Printable View	
TSB 15-0140	LARIAT/PLATINUM/KING RANCH - CLIMATE CONTROLLED SEATS - FRONT SEAT BACKRESTS NOT COOLING
Publication Date: September 8, 2015

FORD: 2015 F-150

Figure 1 - 15-0140

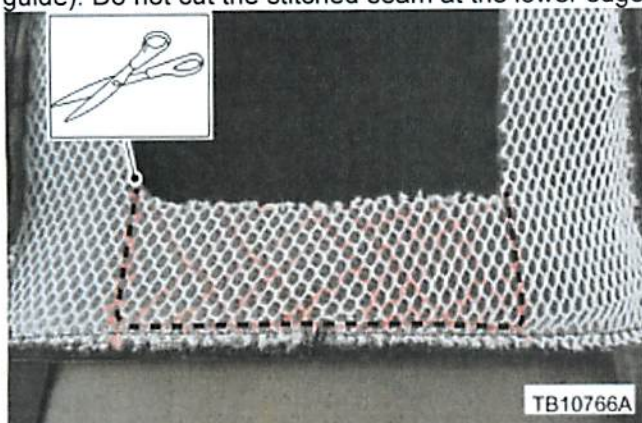
1. Does this vehicle exhibit a lack of cooling in only the front seat backrest when using the climate controlled seats?
 - a. Yes - proceed to Step 2.
 - b. No - this article does not apply. Refer to Workshop Manual (WSM), Section 501-10 for normal diagnostics.
2. Can the backrest blower motor be heard running when using the climate controlled seats?
 - a. Yes - proceed to Step 3.
 - b. No - this article does not apply. Refer to WSM, Section 501-10 for normal diagnostics.
3. Remove the front seat backrest blower motor. Refer to WSM, Section 501-10.
4. With the seat backrest cover positioned upward, use scissors or equivalent cutting device to remove the indicated portion of the seat backrest cover foam spacer pad (using the existing spacer pad opening as a guide). Do not cut the stitched seam at the lower edge of the seat backrest cover. (Figure 1)

Figure 2 - 15-0140

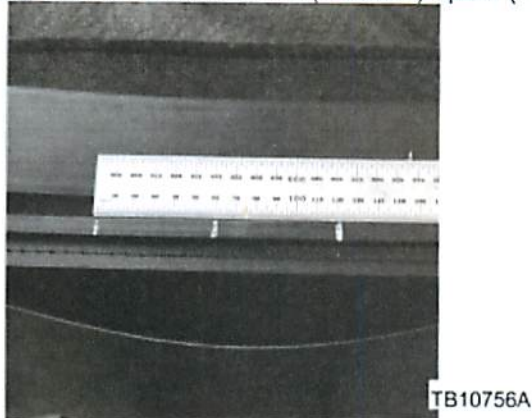
5. Using a scale or equivalent measuring device, locate and mark the center of both seat backrest cover lower J-clips.
6. Measure 60 mm (2 3/8") from each side of the center mark on both J-clips and make two new marks.

- a. These new marks will be 120 mm (4 23/32") apart. (Figure 2)

Figure 3 - 15-0140

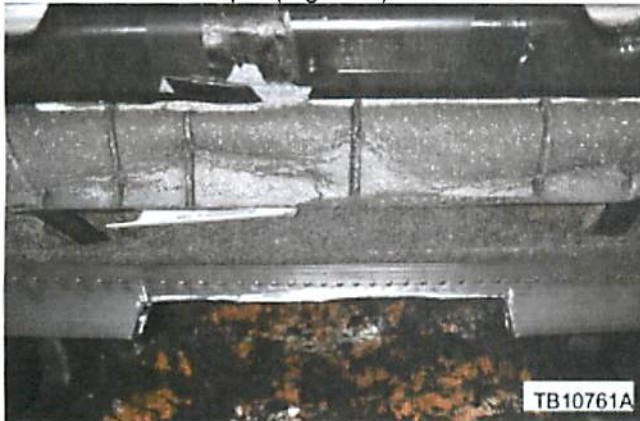
7. Use diagonal cutting pliers or equivalent to remove the plastic J-clip section between these two new marks on both J-clips. (Figure 3)
